# UNITED STATES PATENT AND TRADEMARK OFFICE

APPLICATION NO.	FILING DATE	FIRST NAMED INVENTOR	ATTORNEY DOCKET NO.	CONFIRMATION NO.
10/779,966	02/17/2004	Michael J. Berman	03-1804	9510

<b>Office Action Summary</b>	<b>Application No.</b> 10/779,966	<b>Applicant(s)</b> BERMAN ET AL.	
	<b>Examiner</b> George Nguyen	<b>Art Unit</b> 3723

### **DETAILED ACTION**

**Figure 1**

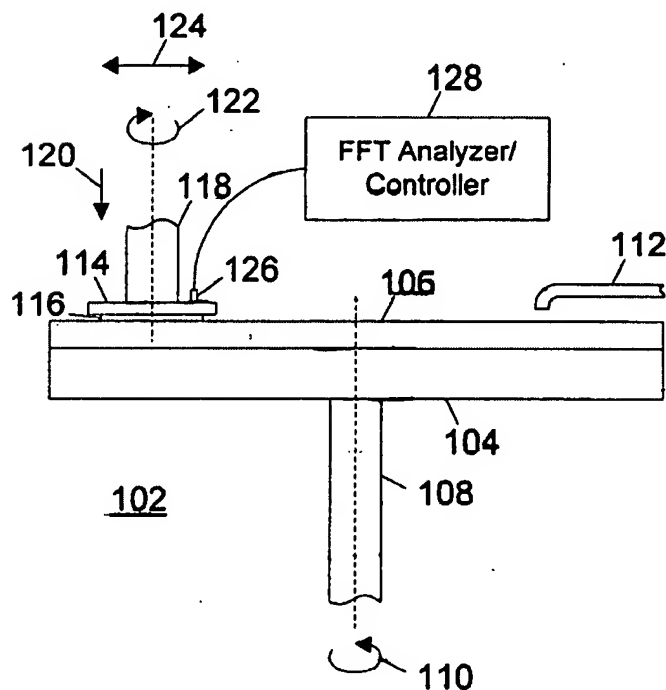
The following is an examiner's statement of reasons for allowance: the specific limitations of "countering the noise associated with ... by changing one or more characteristics of the process" in claim 1, "changing at least one characteristic of the chemical mechanical process to reduce the harmonic oscillation" in the combination as claimed in claim 2, "performing experiments to determine how characteristics of the chemical mechanical polishing process should be changed to reduce harmonic oscillation" in the combination as claimed in claim 13, and "a reactor configured to receive information from the detector and react ... changing at least one characteristic of the chemical mechanical polishing process to reduce the harmonic oscillation" in the combination as claimed in claim 14 are not anticipated nor made obvious by the prior art of record in the examiner's opinion. For example, with reference to Figures 1-2, Sampson discloses an apparatus and method for monitoring CMP process. Acoustic emission samples for CMP polishing process are acquired and analyzed using a Fourier transform to detect wafer vibrations characteristic of scratching. When excess noises levels are detected at frequencies or within frequency bands being monitored, the polishing process is halted. In col. 2, lines 49-59, Sampson discloses that each transducer 126 is connected to analyzer and controller 128, which analyzes the measured acoustic waveform and controls the drive mechanism coupled to wafer chuck 114 and polishing platen 104 and driving mechanical aspect of the polishing process. In col. 3, lines 1-9, Sampson discloses that since the polishing process is at least partially mechanical, abnormal conditions such as the presence of a scratch-causing particle between the wafer 116 and the polishing pad 106/platen 104 may be detected by

abnormal vibrations (acoustic) resulting from scratching. In col. 3, lines 25-29, Sampson further discloses that the presence of a scratch-causing effects will result in the appearance of many harmonics, which renders monitoring of a single frequency (such as for endpoint control purposes) unreliable for scratch detection purposes. From these above disclosures, the examiner infers that Sampson implicitly discloses that scratching-causing effects were caused by harmonic oscillation or abnormal vibrations. However, Sampson does not disclose the step of changing one of the characteristics of the CMP process to reduce the harmonic oscillation.

FIG. 6

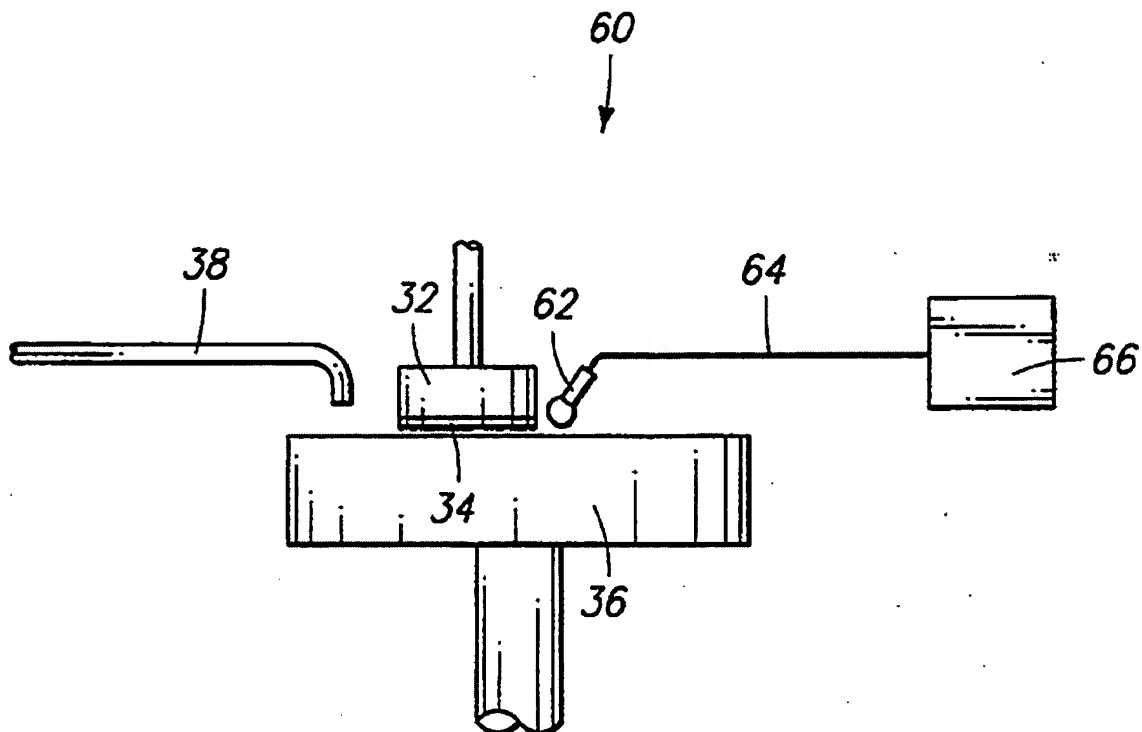
With reference to Figure 6, col. 3, lines 1-12, Meikle et al.'5,439,551 discloses CMP process, upon detecting a change in the sound waves as the CMP polishing action

continuing, changing a chemical-mechanical polishing process operational parameter upon the detection of the change and then continuing chemical-mechanical polishing with the changed operational parameter.

**FIG. 1**

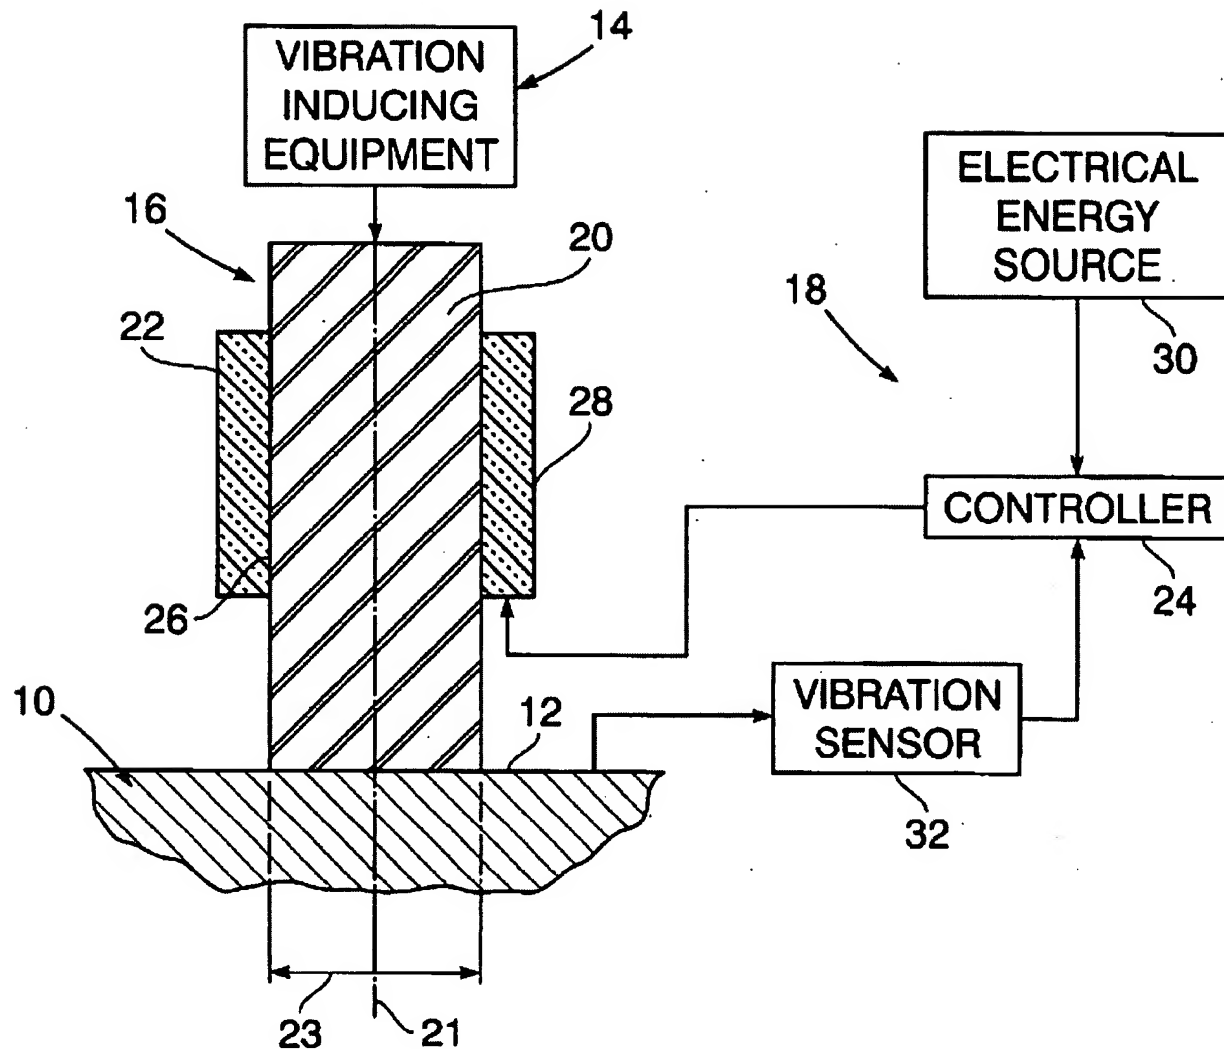
With reference to Figure 1, Jones discloses a piezoelectrically controlled vibration reducing mount system. Equipment having a source of vibration associated therewith is mechanically supported with strict positional tolerance on the floor surface by an elastic cylinder made of rubber. Such elastic cylinder is stiffened by a bulge restricting sleeve made of piezoelectric ceramic material so that fluctuating voltage applied thereto from a source of electrical energy under active control, during the continuous sensing vibrations transferred to the surface, null the bulge restriction of the stiffening sleeve to reduce the vibrations transferred to the surface within the operational frequency range of the vibration source associated with the equipment.

Fig. 2

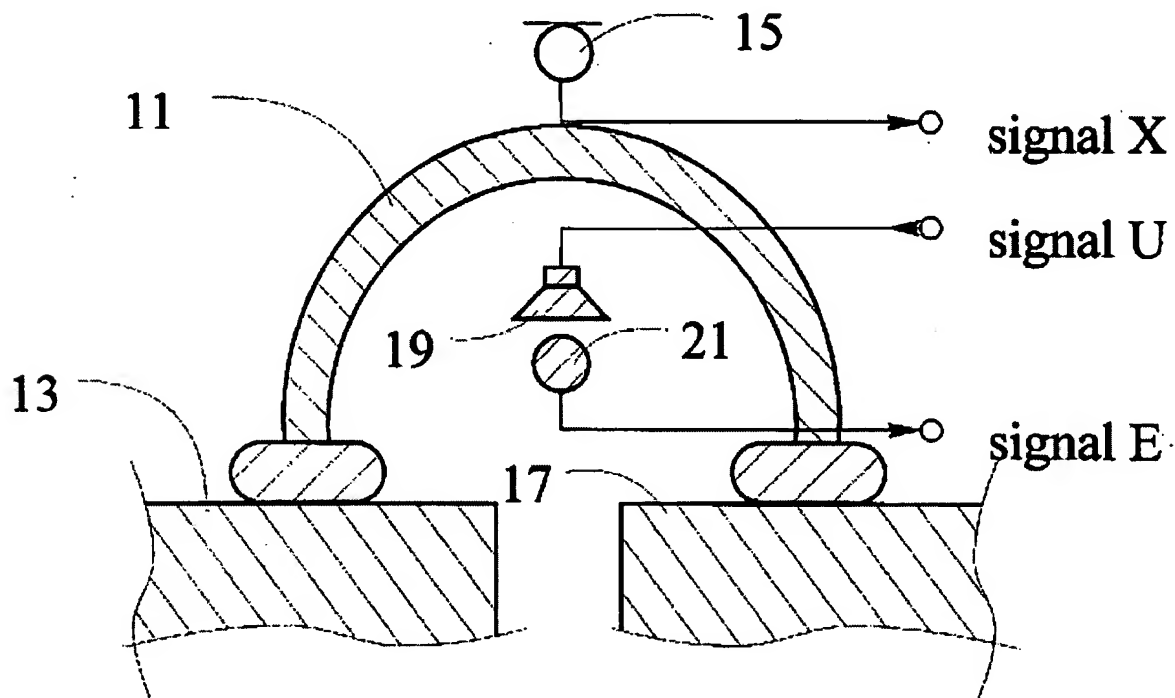
With reference to Figure 2, Pan et al.'5,852,667 discloses a digital feed-forward active noise control system. In Figure 2, a sound attenuating earcup 11 is fitted over the ear 13 of a user, and seals to the skin of the user. A reference microphone 15 is located just outside of the earcup, e.g. on an axis with ear canal 17 of the user. An electroacoustic transducer (earphone 19) is located within the volume between the earcup 11 and the

ear 13, also preferably on the axis with the ear canal and microphones 15. An error microphone 21 is also located in the volume between the earcup 11 and the ear 13, also preferably on the aforementioned axis.
